REVISED

STHD Built-in tab plus!

F-STHDTAB05 2/05

New
Built-in Tab
Feature

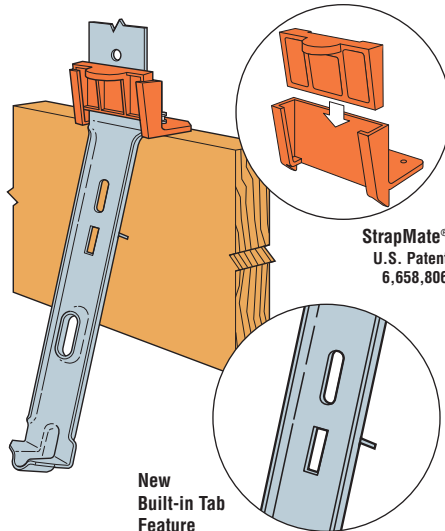
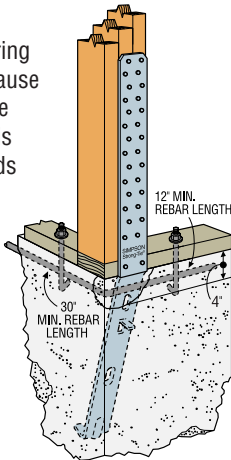
New Features:

- Built-in tab
- StrapMate locator line
- Additional diamond hole on rim joist versions

Built-in Tab:

- Holds STHD away from the formboard
- Reduces spalling and costly retrofits
- Prevents movement of STHD back into the formboards

StrapMate Locator Line:

- Easy inspection to ensure proper location
- Allows adjustment without removing strap

Additional Diamond Hole:

- One more fastener to help prevent the STHDRJ from bowing out at the rim joist section
